Hi-Fi Audio	Quick Service Manual		Ref. No.: HA-97-195
			Date: Nov., 1997
	Model: SA-CH64/84/94 all series SA-AK70/90/75 all series SL-MC50/59/409/60 all series	Frequency: C	Cases reported (country) Panama

Subject: "Error" Indication in Disc Search

Hi-Fi Audio	Quick Service Manual		Ref. No.: HA-97-196
			Date: Nov., 1997
	Model: SA-CH64/84/94 all series SA-AK70/90/75 all series SL-MC50/59/409/60 all series	Frequency: C	Cases reported (country) U. K

Subject : Mechanism jamming problem

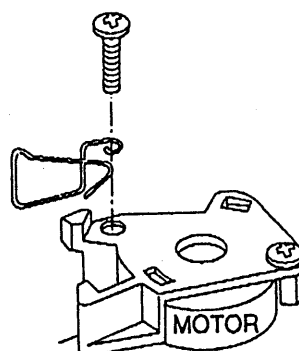
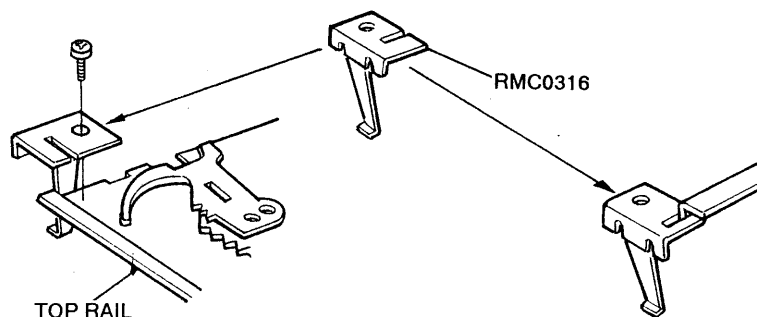
Symptom: "Error" Indication after Disc Search mode.

Cause: The teeth of slide gear is shifted due to vibration or/and shock in transportation.

Remedy: 1) Add lock plate spring (RME0025) on loading mecha motor.

2) Add Balance spring (RMC0316) on top rail.

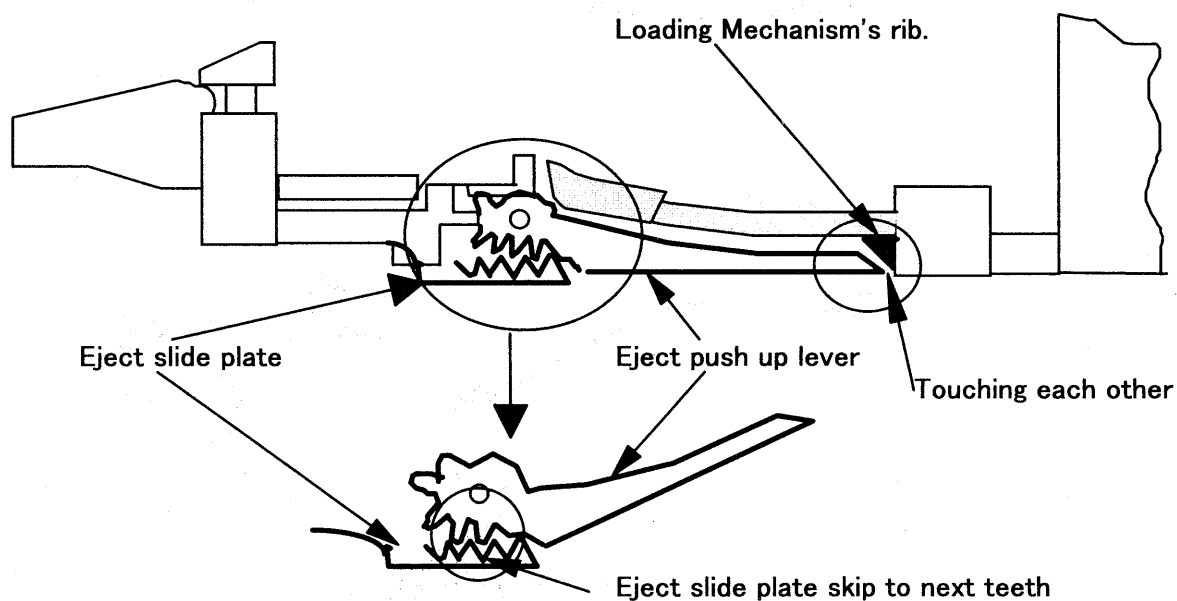
Symptom : Traverse Loading Mechanism doesn't move at all.

Cause : According to our investigation result, This is for only one situation such as below.

- 1) When the Eject Lever was pressed, while eject Lever position was same number with play position (example : 10 slot), it will touch to Loading Mechanism's rib.
- 2) Then if the Eject Lever was pressed more strongly, The gear of Eject slide plate will be skip to next teeth.
- 3) Usually the Eject side lever will be go back to initial position by spring, but in this case it doesn't go back to initial position for gear sticky. So Eject Lever will stay upper position.
As a result, Loading Mechanism movement is disturbed.

- 1) Change eject push up lever Ass'y from old type (RFKNLMC50PEK) to new type (RFKNCH64MP-K).
- 2) Change eject slide plate from old type (RML0439) to new type (RML0439-1)

< Improvement Point >

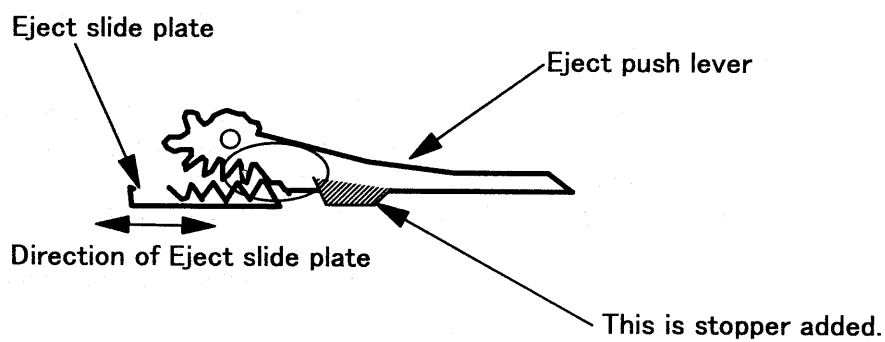
1) Eject push lever add material. (change shape)

2) Eject slide plate
